# CORRECTED CONDOMINIUM MAP OF HIGH ALTITUDE AERO HANGAR CONDOMINIUMS

A PORTION OF THE NORTHWEST QUARTER OF SECTION 4  
TOWNSHIP 13 SOUTH, RANGE 64 WEST OF THE 6TH P.M.  
COUNTY OF EL PASO, COLORADO

PCD FILE NO. SF2414

Field: TEC/CEF Drawn: TEC/CEF Checked: CEF PROJECT No.: 24000 SHEET 1 OF 2

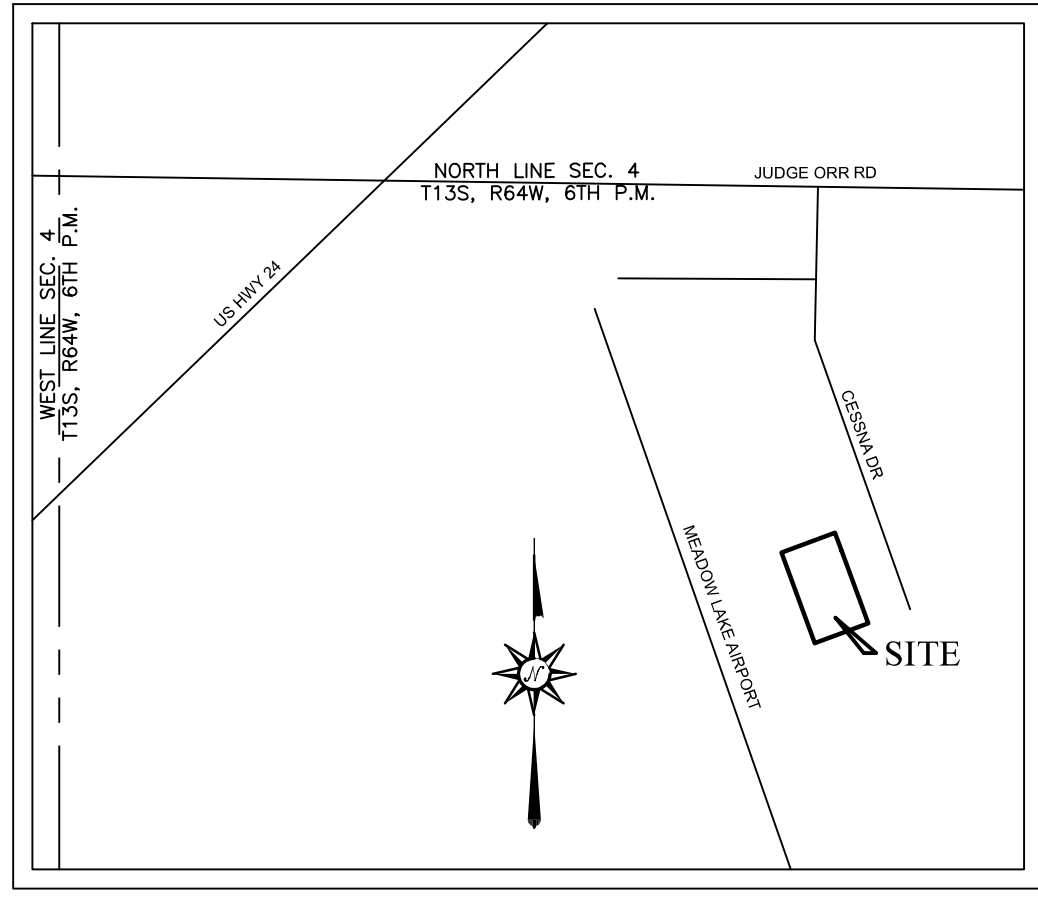
Please remove.
